EDMC#: 0000003
SECTION: 10 OF 11

DOCUMENT #: DOE/EIS-0113

TITLE: Final EIS Disposal of Hanford
Defense High-Level, Transuranic
and Tank Wastes

Figure V.

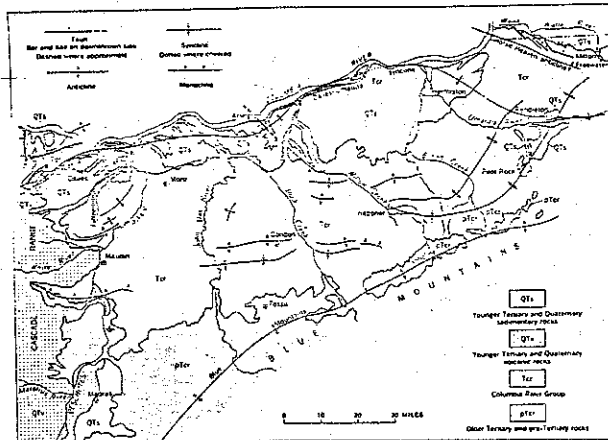
Evidently, the department doesn't want to clean up the over 500,000 cubic yards of defense waste that has been put into the ground. Given the existing plutonium that is in the groundwater (DEIS, figure V.17), why aren't any water barriers or impermeable seals planned to intercept more leaks?
